# UNITED STATES PATENT AND TRADEMARK OFFICE

APPLICATION NO.	FILING DATE	FIRST NAMED INVENTOR	ATTORNEY DOCKET NO.	CONFIRMATION NO.
09/923,288	08/06/2001	Hubert T. McGovern	OMG/129/US	9047

# Office Action Summary

## **DETAILED ACTION**

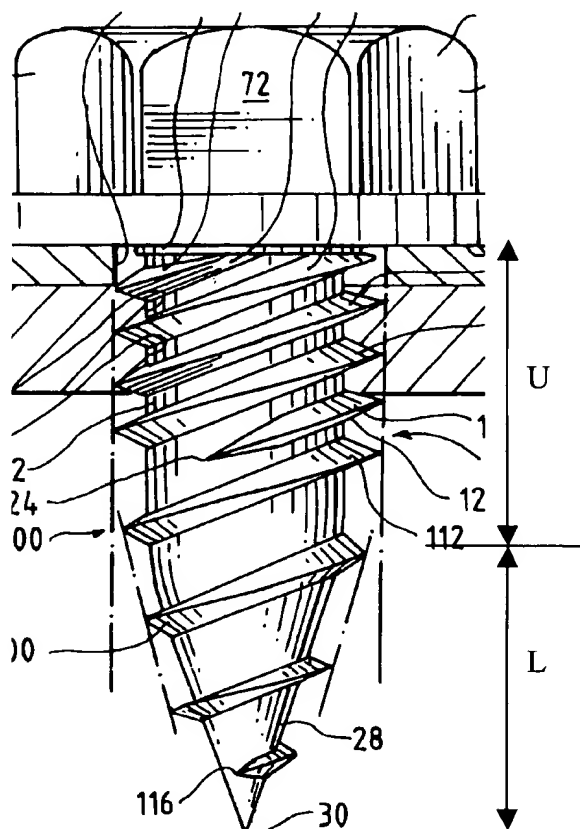
Regarding the claims, Hsing discloses a screw shaft and head, the head provided with a top surface 72 being able to receive a tool, the shaft provided with a threaded upper region 120, which refers to the entire upper region of the shaft (also labeled as U on the Figure below), located proximate the head and a threaded lower region 100, which refers to the entire lower region of the shaft (also labeled as L on the Figure below), near a distal end of the screw, the distal end having a tip 30, the cross sectional area of the shaft in the upper region being greater than that of the shaft in the lower region, and the

number of threads per unit length in the upper region being at least twice the number of threads per unit length in the lower region. Hsing further discloses the thread pattern of the lower region being symmetrical.

15. Applicant argues that Hsing fails to disclose "a shaft with a cross sectional area in the upper region greater than the cross sectional area of the shaft in the lower region". The examiner respectfully disagrees. Although Hsing discloses shank 22 being "generally cylindrical", this is only referring to the upper region of the shank. Both the cylindrical portion 22 (also labeled as U on the figure above) and lower tapered portion 28 (also labeled as L on the Figure above) are considered to make up the entire shank of the screw. This lower tapered region 28 (or L) clearly has a smaller cross sectional area at any given point than the cross sectional area of upper region 22 (or U) and therefore reads on the claimed screw. The rejection is therefore deemed proper and is maintained.
